Re: CONCEPTUAL LONG TERM MONITORING PLAN (CLTMP), SITE 07, CALF  
PASTURE POINT, NAVAL CONSTRUCTION BATTALION CENTER (NCBC)  
DAVISVILLE, RI

# Conceptual Long Term Monitoring Plan Site 07, Calf Pasture Point Davisville, RI

**Response to EPA/RIDEM Comments**  
**on**  
**Draft Conceptual Long Term Monitoring Plan**  
**Site 7 Calf Pasture Point**  
**Former Naval Construction Battalion Center, Davisville, RI**

FIGURE 1  
SITE MAP

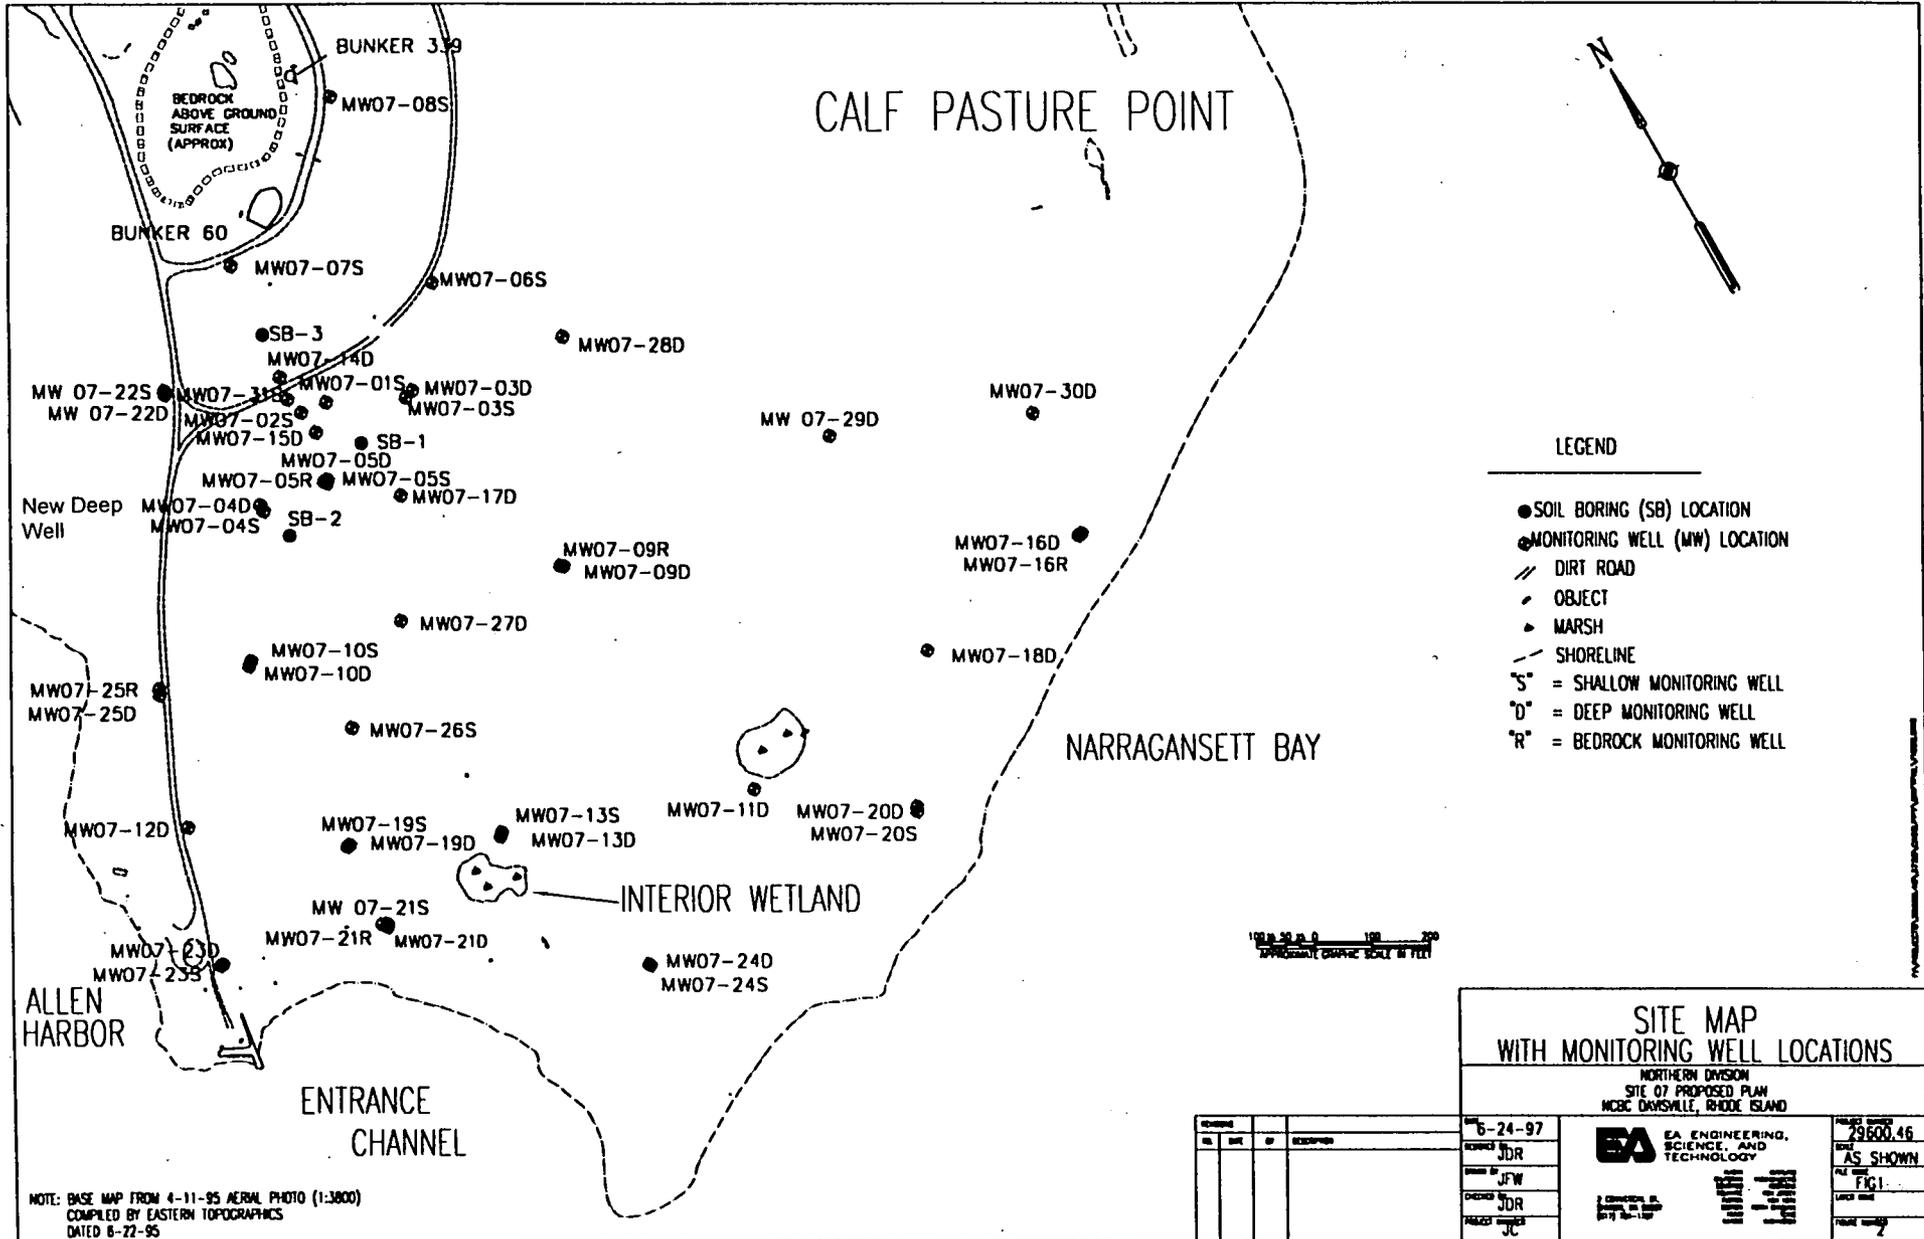
**EPA Specific Comment 7 (Section 4.1 Baseline Sampling/Measurements, (3) Deep well Samples, Page 5):** *A shallow bedrock well, as well as "a new deep well west of MW07-4D", is needed in this part of the site.*

**Response:** As noted above, the depth of the proposed new well has been selected consistent with CVOC plume delineations performed during the RI, which are supported by data from numerous shallow, deep and bedrock wells. Therefore, at this stage, additional cluster wells are not deemed necessary.

Figure 2.  
 Conceptual  
 Long Term Monitoring Plan  
 Calf Pasture Point

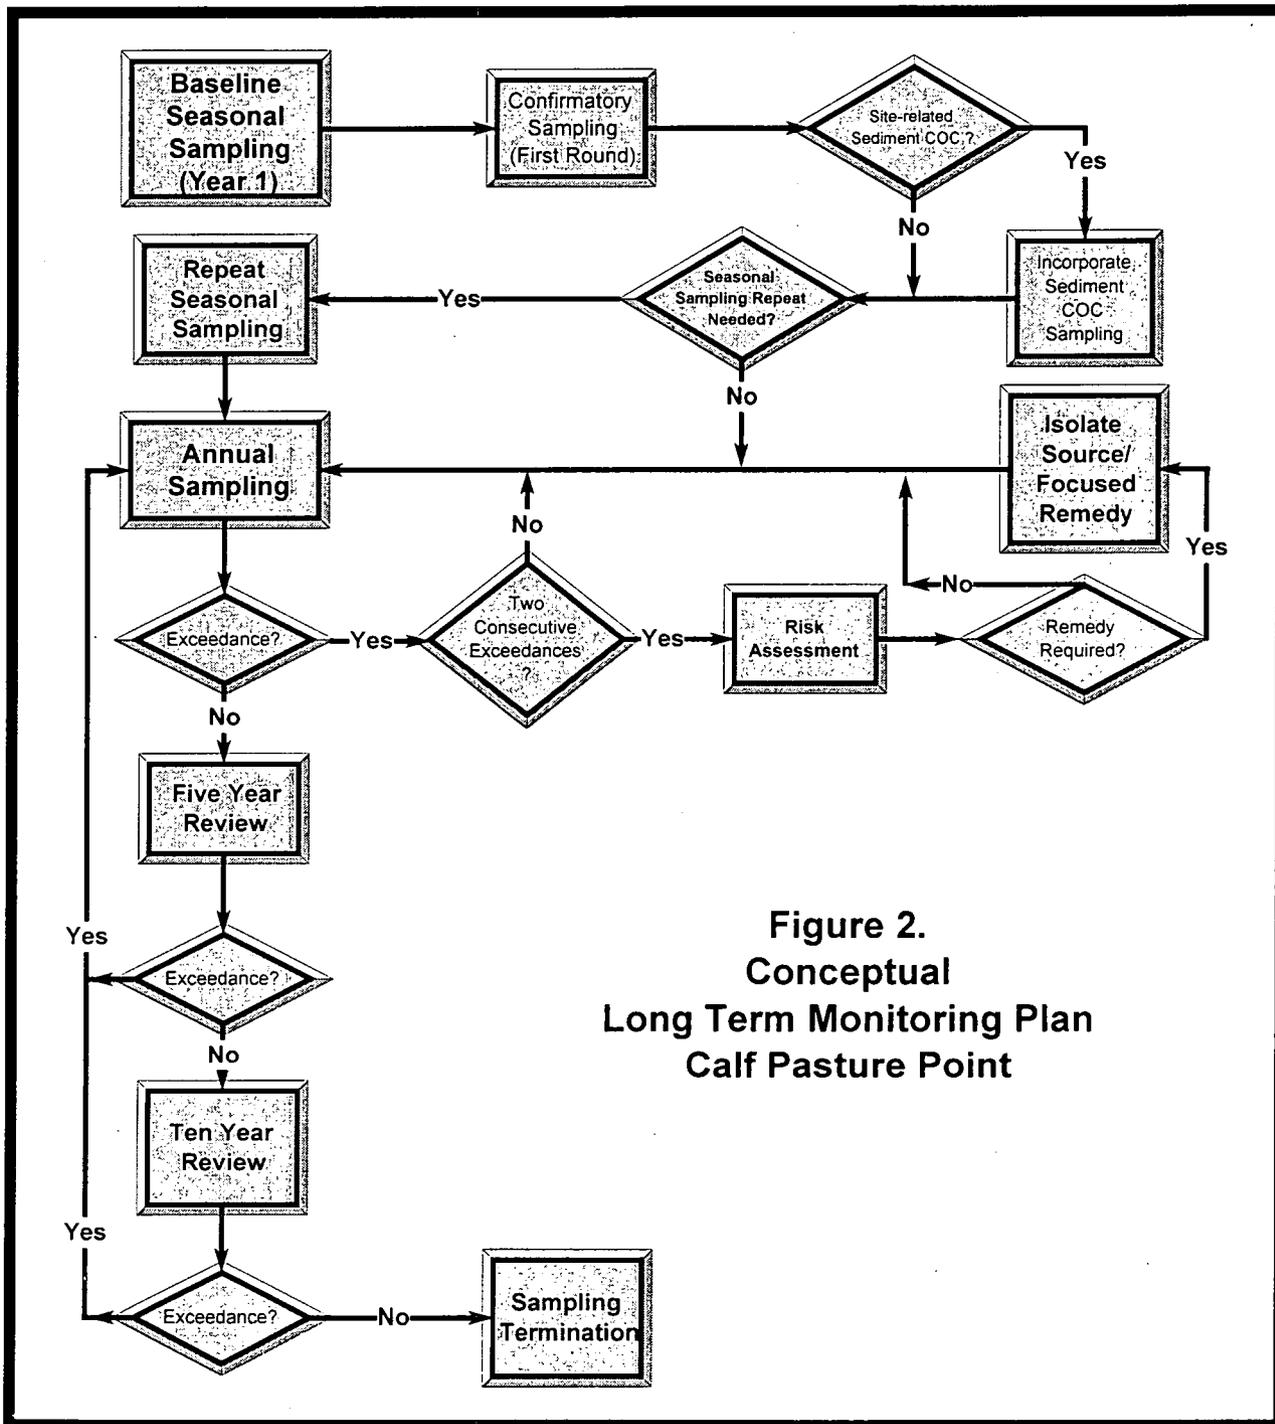
**EPA Comment 16 (Section 4.4 Post Baseline Monitoring, (2) LTMP Scale Down, Page 8):** *This section states that after two consecutive sampling rounds in which no exceedances or significant increasing trends were identified, sampling can be discontinued. According to this proposed plan, all groundwater monitoring can be stopped after two years. This is not consistent with ensuring protection of human health and the environment, especially in light of the fact that there is unacceptable risk at the source, it is not documented that the entire plume is in a stable state, nor is it consistent with Figure 2 (flow diagram). Figure 2 indicates a minimum of ten years of monitoring.*

***EPA Specific Comment 19 (Figure 2):*** *The Figure needs to be amended so as to provide for inclusion of regular 5 year reviews as specified by the CERCLA process as long as an unacceptable risk remains at the site. A box for "risk assessment" is needed prior to "Isolate Source/focused Remedy. The "Site-related Sediment COC" needs to be evaluated on an ongoing basis (i.e., not on the basis of a sole "confirmatory sampling" round), including inorganics as site related indicators. Sediment sampling at the discharge zones must be performed as part of the annual sampling in order to understand the partitioning of groundwater contaminants up through the sediments from deeper to more shallow zones.*

1. Further explanation of primary COC is provided in Section 2.
2. Monitoring strategies related to the source area remedies, i.e. deed restrictions and institutional controls, are stated in Section 3.
3. Interior wetland sampling is incorporated as a component of all monitoring activities as discussed in Section 4.1 (item 2).
4. Anomalous baseline period is defined in terms of climatic data in Section 4.2 (item 4).
4. Section 4.4 (item 1) discusses the repetition of seasonal sampling.
5. The revised plan does not use attenuation factors. Consequently, threshold values are defined for shoreline piezometers only, as discussed in Section 4.3.
6. Prior to any focussed remedy, a risk assessment will be conducted to evaluate the need for remediation, as discussed in Section 4.4 (item 2).
7. Figure 2 has been revised to reflect these changes.

**Response:** The above comment is noted. The revised CLTMP is modified by incorporating a risk assessment "node" within the CLTMP decision flow diagram.

**Response:** The revised Figure 2 will contain a box for risk assessment prior to the "isolate source/focused remedy." At this stage, given the wealth of information on sediment contamination at Allen Harbor, the proposed one-time confirmatory sampling is adequate. Subsequent measurements, including the confirmatory sampling, may justify additional sediment investigation.
